SUNDRY NOTICES AND REPORTS ON WELLS

LAGUNA DEEP FEDERAL #4

API 30-025-30695

Laguna Deep Federal 4
30-025-30695
Cimarex Energy of Colorado
February 22, 2010
Conditions of Approval

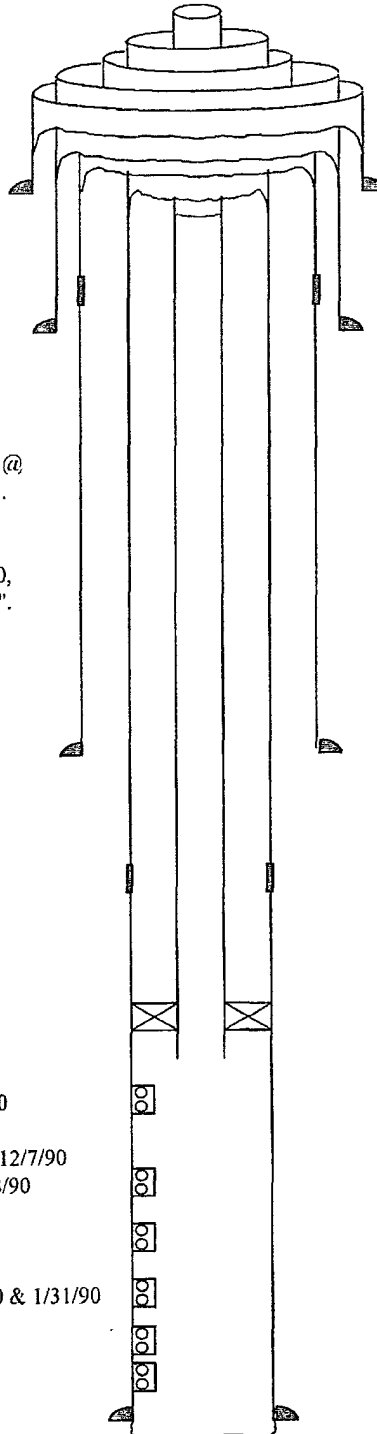
1. Tubing must be cut and CIBP set within 100' above the top perforation.
2. Top of plug to be at 12,820' or shallower, otherwise ok. (Top of Morrow at 12,872')

3. Ok.
4. Move plug to cover Wolfcamp from 11,030'-10,830'. (Top of Wolfcamp at 10,982')
5. Tag plug across DV Tool, otherwise ok.
6. Ok. (Bone Spring at 8,067')

7. Tag plug a minimum of 50' above casing shoe, otherwise ok. (Top of Delaware and 9-5/8" casing shoe)
- 8-9. Well is in R-111-P this requires a solid plug from 3,170'-1,433' in and outside of the casing from base of salt to the top of salt and it must be tagged a minimum of 50' above the casing shoe at 1,433'.

- a. Top of cement is at 2,900', perforate at 2,850' attempt to establish injection rate, if rate cannot be established spot a 25 sx plug 50' below perforations, WOC and tag.

- b. Continue to perforate and squeeze cement until the casing and annulus are filled to 1,433'.
10. Ok
11. Ok.
